**GOODWIN UNIVERSITY EDUCATIONAL SERVICES, INC.**  
**Special Meeting of the School Building Committee**  
**May 12, 2026 at 12:00 pm**

Goodwin University  
Magnet Technical High School  
State Project #542-0007 MAG/N

**Subject: Progress Report**

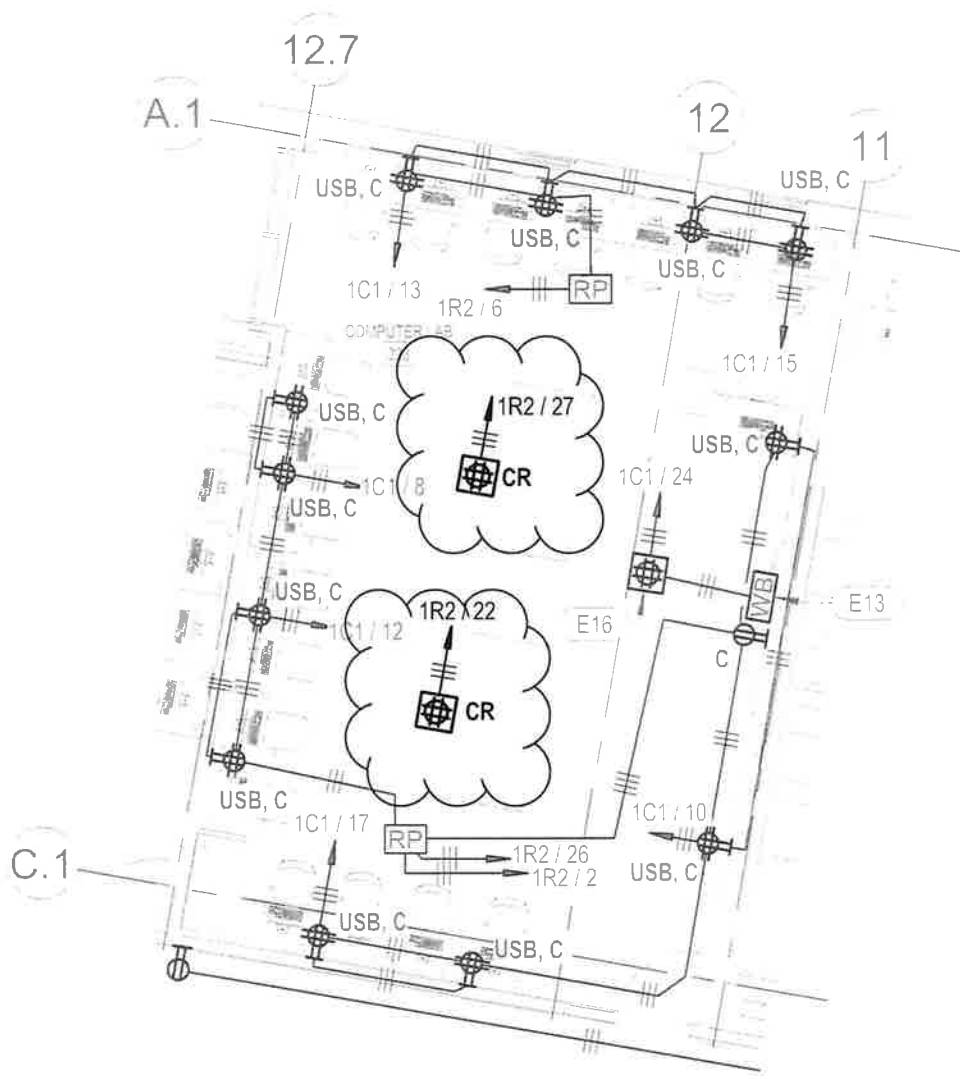
Please provide a cost proposal to add or remove power and data to Shop Maker Space 116, Computer Labs 222 and 223 and Tech Breakout 224 based on attached sketches and list of revisions below.

- Shop Maker Space 116: Remove data above the teaching tables.
- Computer Lab 222: Add data and power. Remove floor boxes for data
- Computer Lab 223: Add data and power. Remove floor boxes for data
- Tech Breakout 224: Add data and relocate the receptacle on west wall

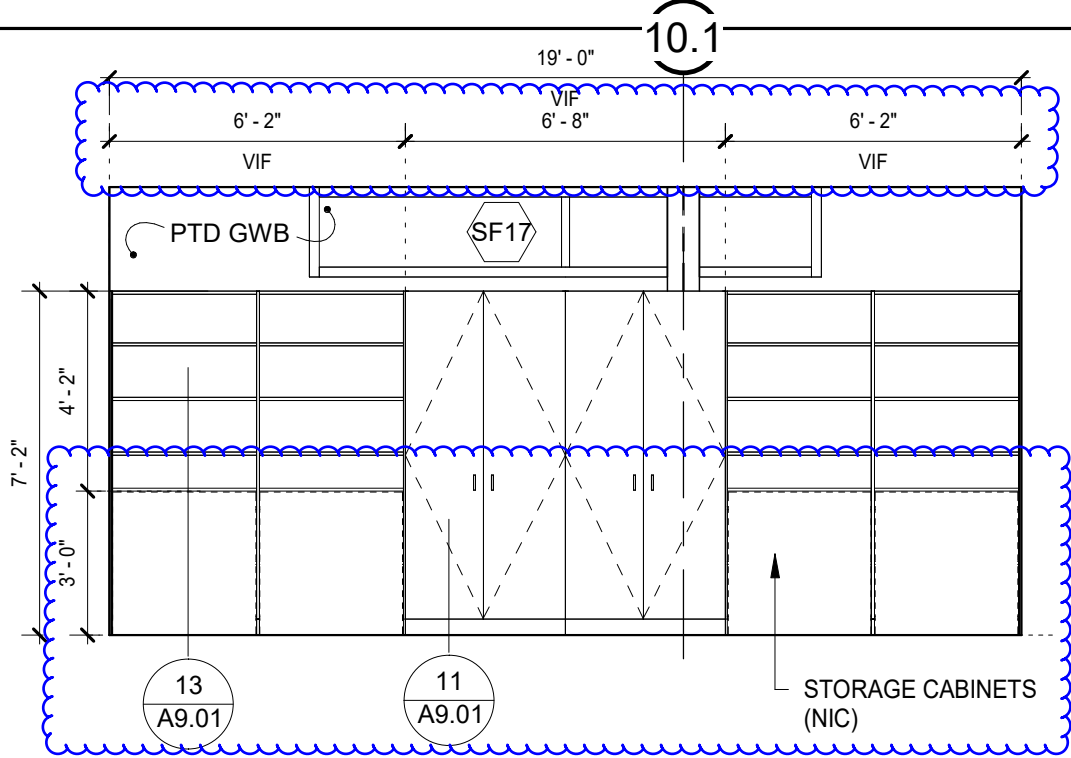
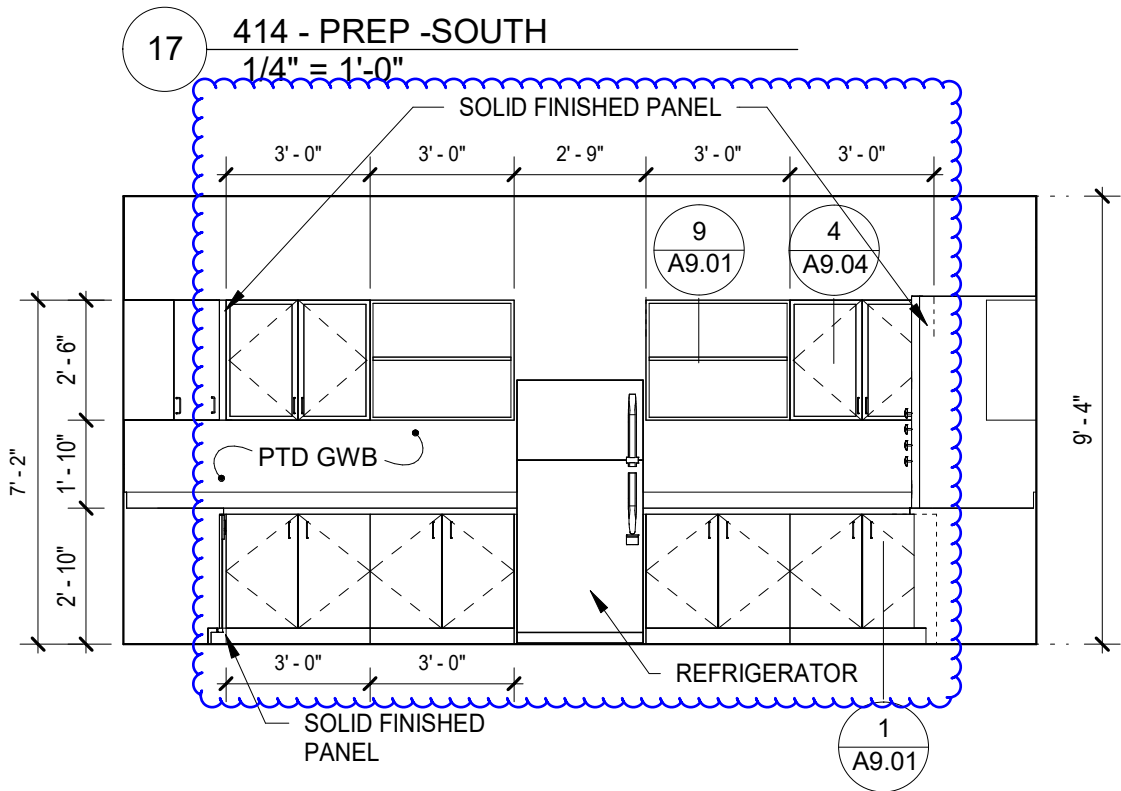
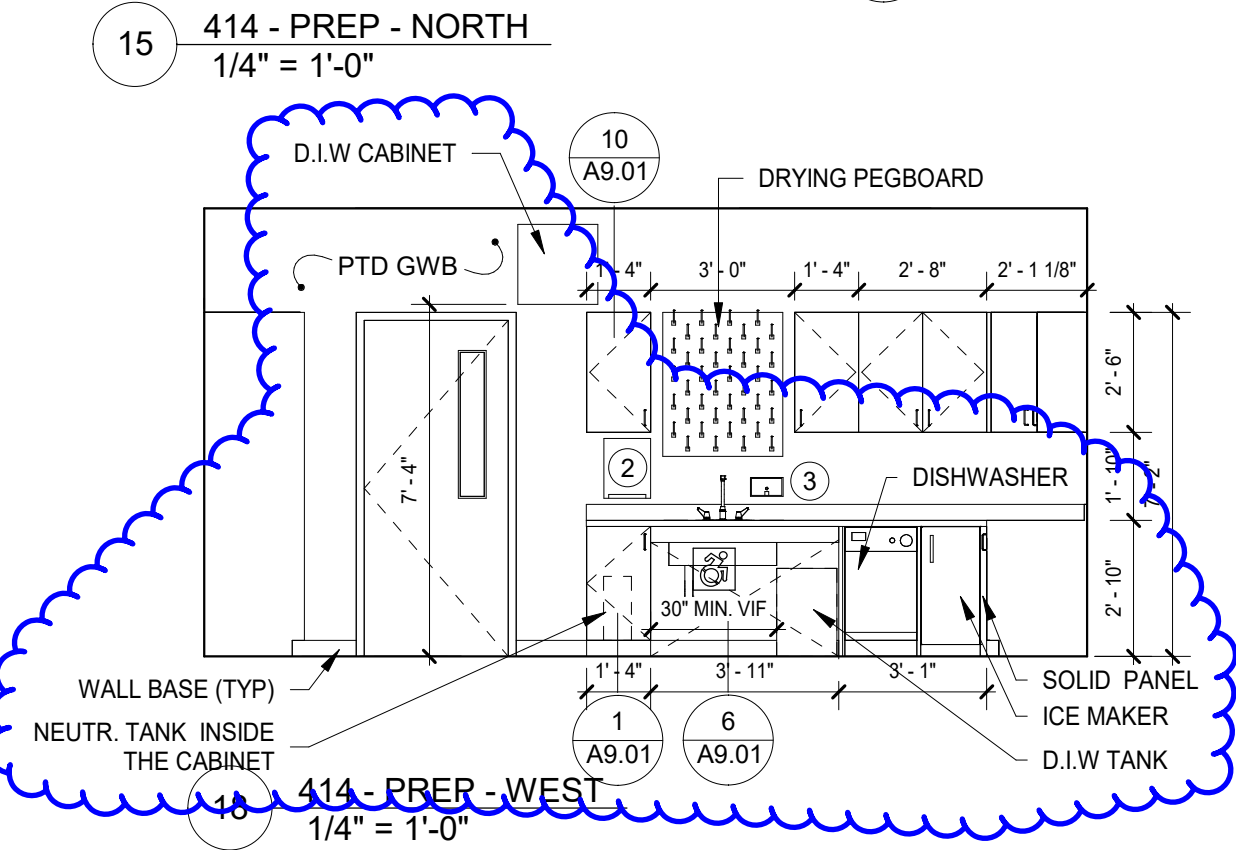
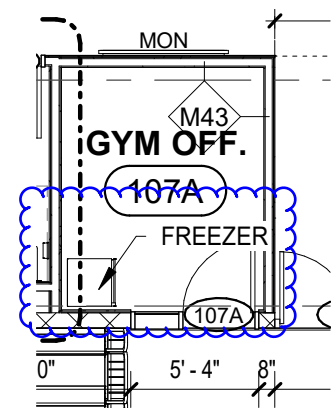
Please provide a cost proposal to add appliances and to revise casework and MEP layout in Prep Room 414 and Gym Office 117A based on attached sketches. Please also add gas connection to science classroom and prep room fume hoods.

| TSKP<br>STUDIO<br>One Hartford Square West<br>146 Wyllys Street, Bldg. 1-203<br>Hartford, CT 06106 • 860.547.1970 | JOB NAME / NUMBER:<br>GOODWIN INDUSTRY 5.0 HIGH SCHOOL |                    | TITLE:<br><b>PREP ROOM CASEWORK<br/>MODIFICATION</b> | DRAWING NO:<br><b>SKA-32</b> |

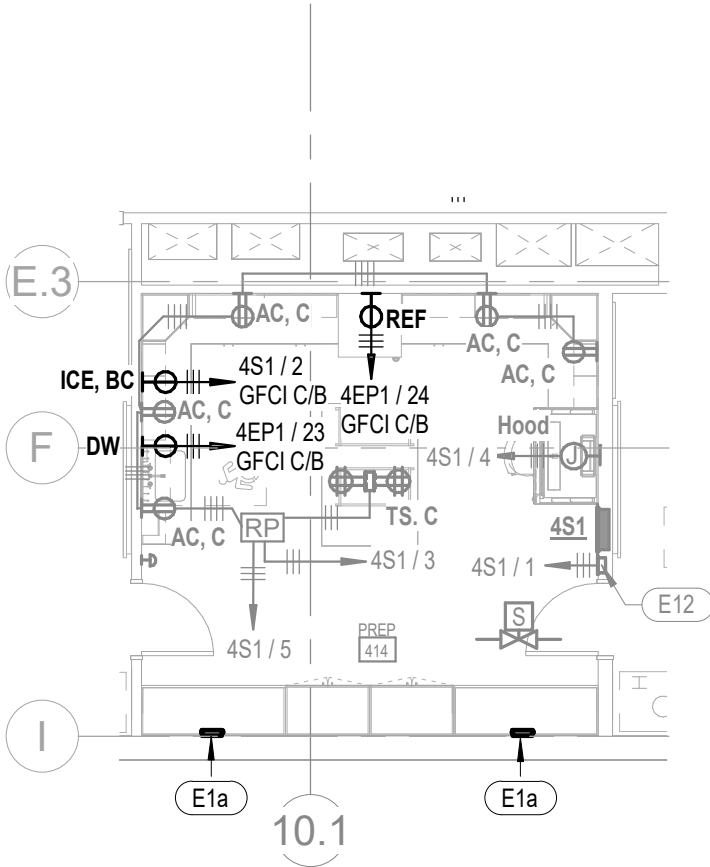
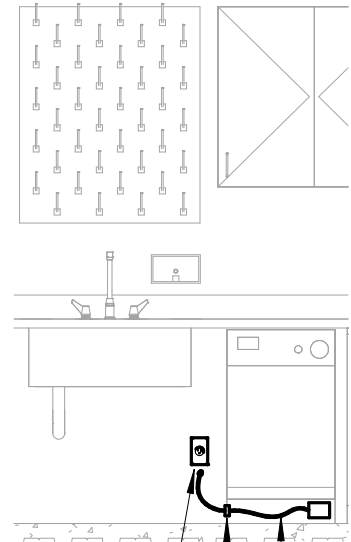
**PARTIAL FIRST FLOOR PLAN**  
Scale: 1/8" = 1'-0", Ref. 1 /A1.11

NOTE: PROVIDE BASIS OF DESIGN PRODUCT LISTED BELOW OR A COMPARABLE PRODUCT FROM A MANUFACTURER LISTED ON 113100 - RESIDENTIAL APPLIANCES, SECTION 2.1.A.

Refrigerator: GE Appliances, Model GBE17HYRFS – Stainless steel  
Dishwasher: GE Appliances, Model PDT145SSLSS – Stainless steel  
Ice Maker: Summit Appliances, Model BIM44GCSSADA

Freezer: Summit Appliances, Model Accucold FS407LW

GHS PR-33 TB / Slat Wall Revisions Take-off

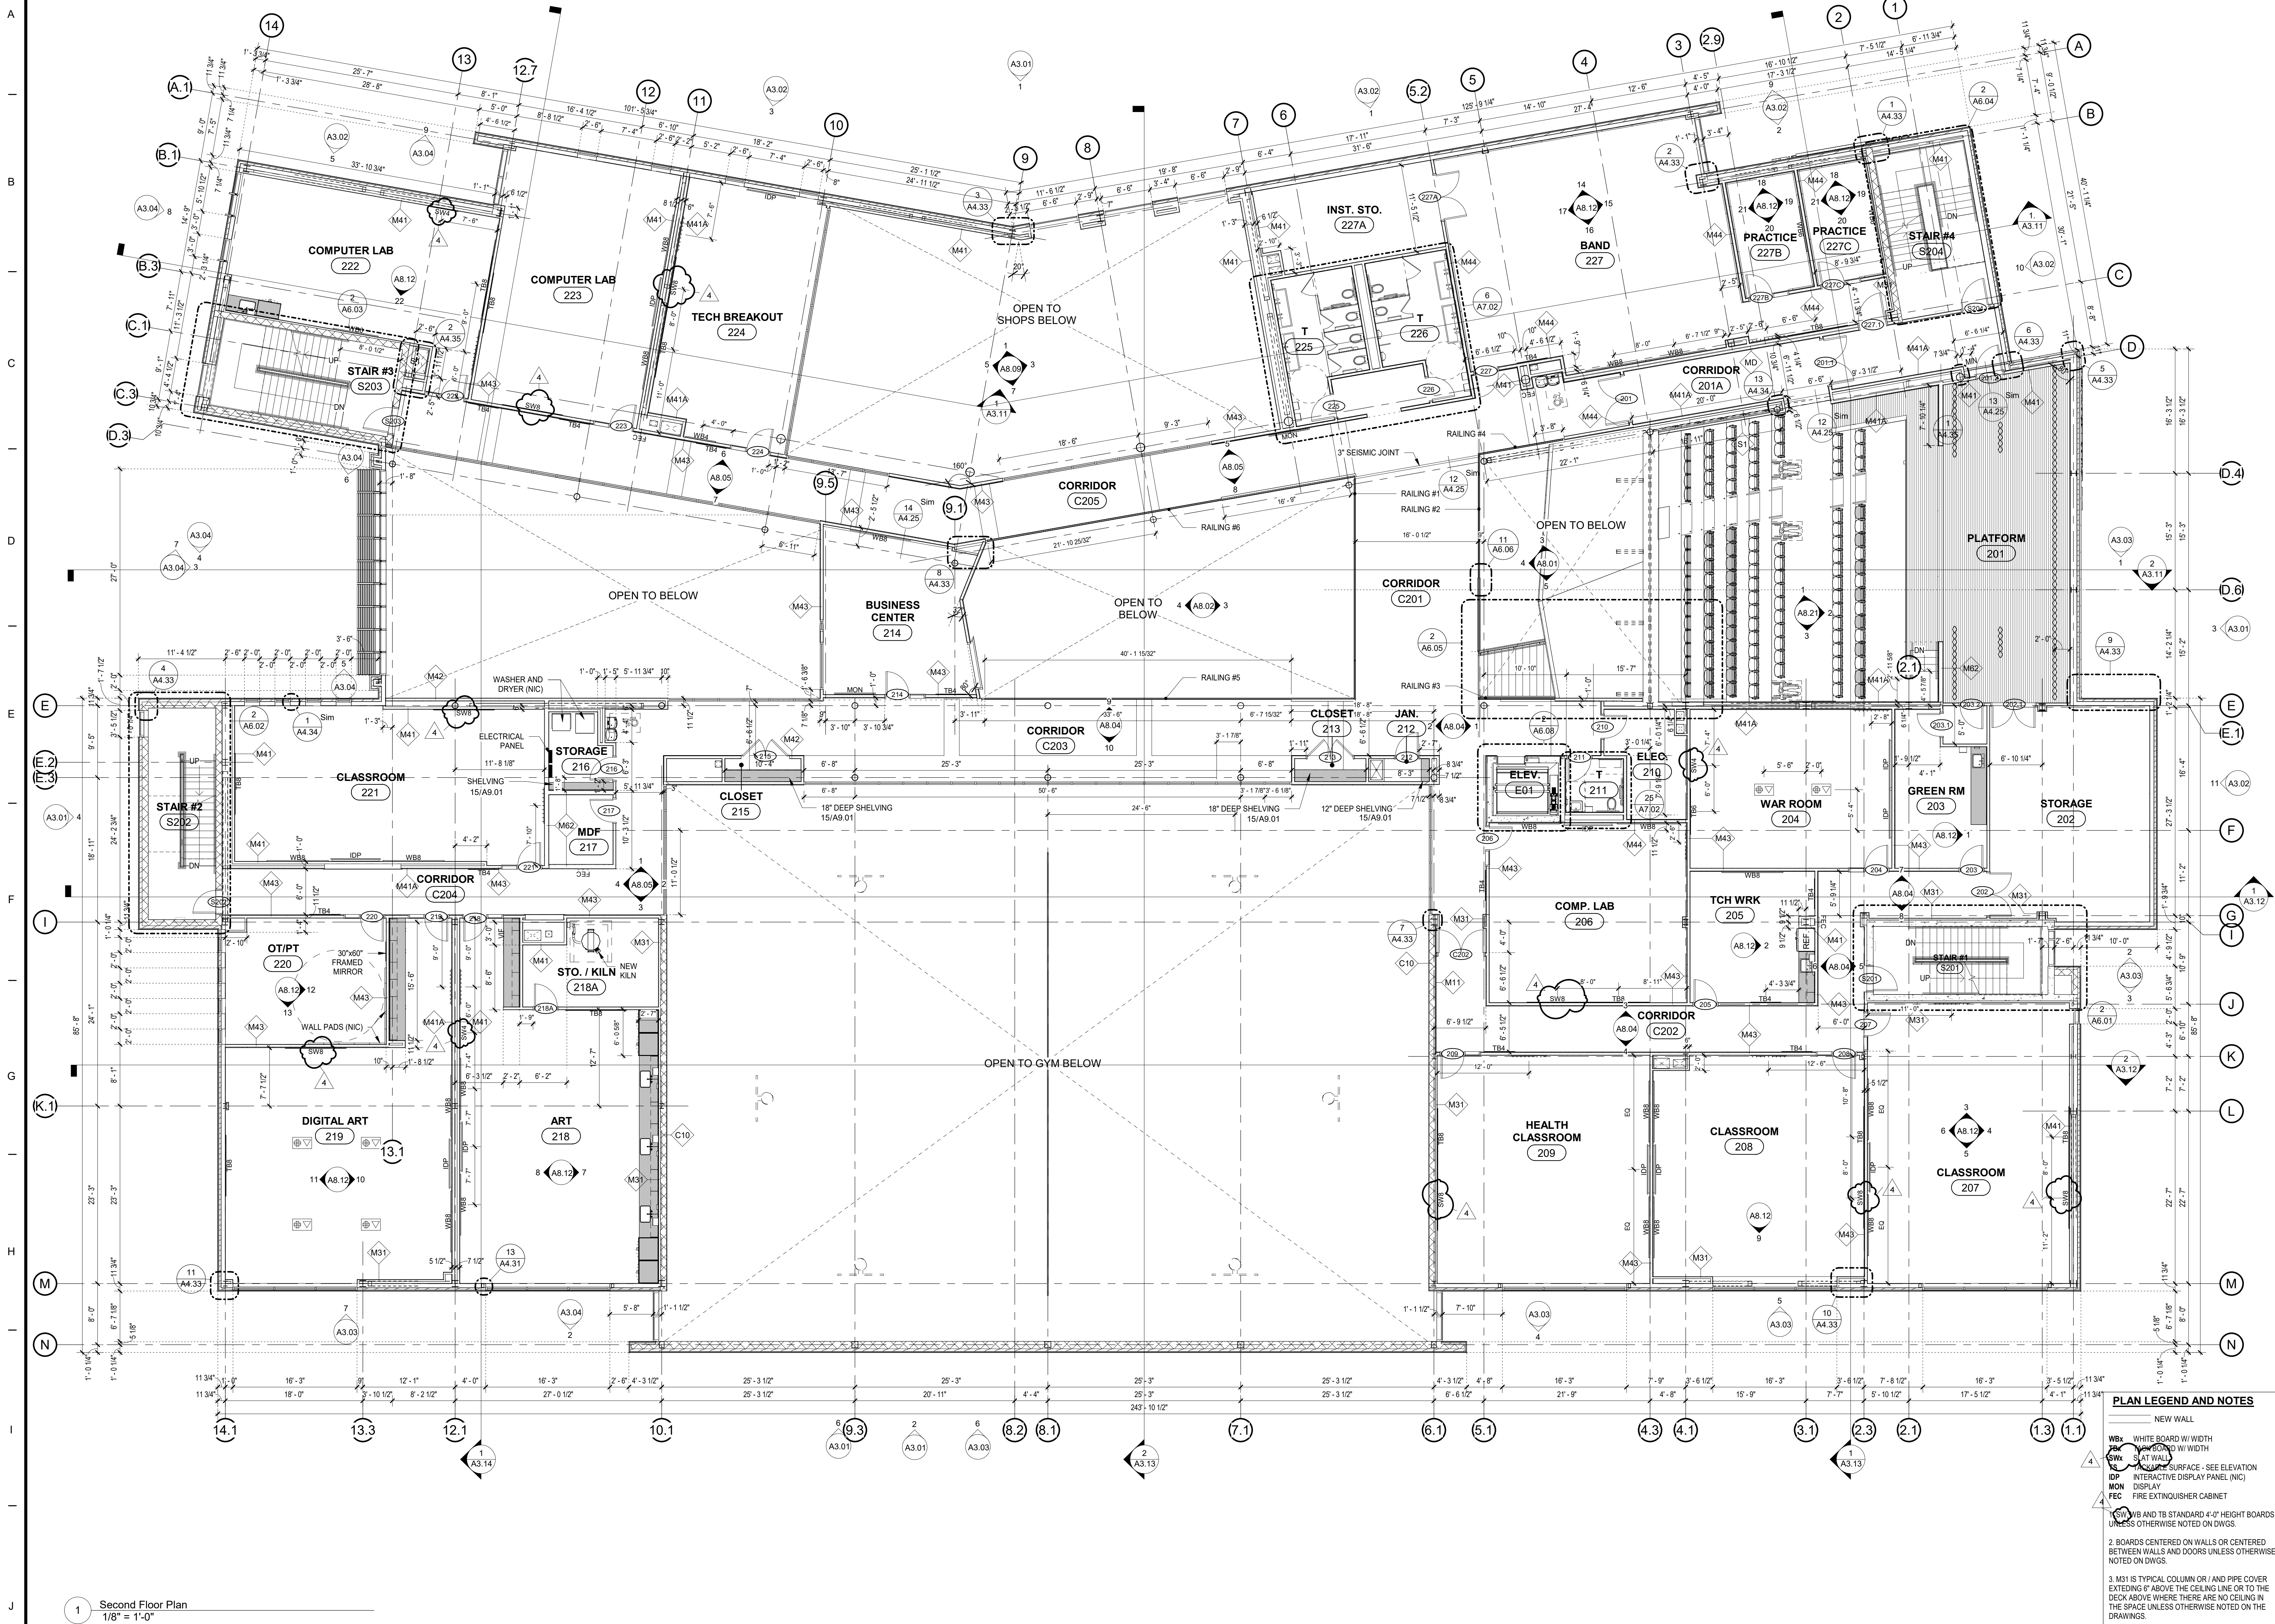
Please provide a cost proposal **to add slat wall or replace TB with a slat wall** as indicated on attached floor plans and take-off documents.

Provide slat wall from the manufacturer based on specs listed below or an equal product from a different manufacturer.
